LaBounty Disposal Site

→ LBTD Shutdown – Response to February 15, 2022 Comments

EPA Comment Letter – February 15, 2022

Conceptual Site Model - Discharge to River

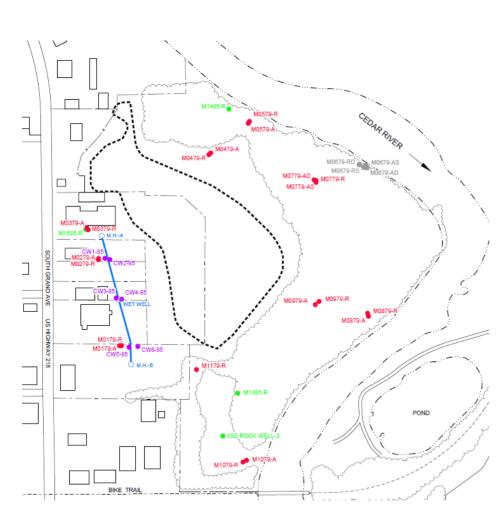
Model Used and Model Inputs (EPA Comment 1)

- Spreadsheet calculations used to estimate the effect of the LBTD system on reducing groundwater and mass discharge to the Cedar River.
- Groundwater and Mass Flux calculation actual field and laboratory measurements.
 - Calculations demonstrate minimal influence of LBTD
 - Low discharge Reduction of 0.4%
 - High discharge Reduction of 1.6%
- Calculations are conservative when extended to estimate surface water concentrations.
 - Overestimates loading to Cedar River (compared to actual surface monitoring data).
 - Do not account for attenuation of arsenic at groundwater-surface water transition zone.

- Highest arsenic in groundwater shallow alluvial aquifer.
- Arsenic attenuation occurring.
- During low river stages, low groundwater conditions are expected.
 - Reducing groundwater and arsenic flux to river.

2016 Sampling Summary (Golder, 2017)

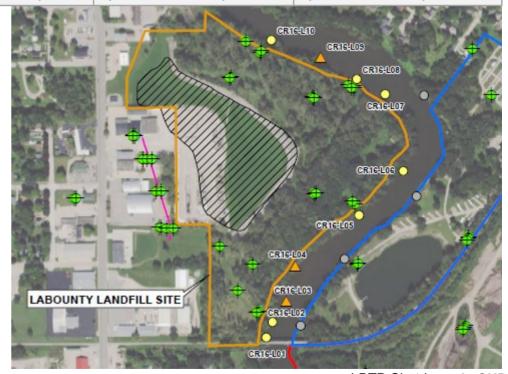
Ongoing sediment and pore water sampling (EPA Comment 7)

- Surface water and sediment concentrations were 1 2 orders of magnitude below screening values.
- Two discrete exceedances in pore water (surface water ecological screening value).
 - Mean and 95% UCL for pore water < surface water screening value.
- Pore water 95% UCL < screening value for infaunal species.

- 2015 Five-year Review Surface water, sediment, and pore water sampling completed (2016)
 - Two pore water samples > surface water screening levels.
 - Localized arsenic transport to the Cedar River may occur
 - Adverse impacts on ecological receptors are not likely localized nature of any impact
- Five-Year Review Addendum, EPA (Feb. 2019)
 - "No further investigation or assessment be performed to assess potential arsenic impacts from the Site, other than annual surface water monitoring in a location directly downstream of CR16-L06 to confirm no material changes."
 - EPA concurred with minimal effect of LBTD on groundwater flow and discharge to Cedar River.
- Recommend continue with annual surface water sampling directly downstream of CR16-L06.
 - Included in approved monitoring and maintenance plan.
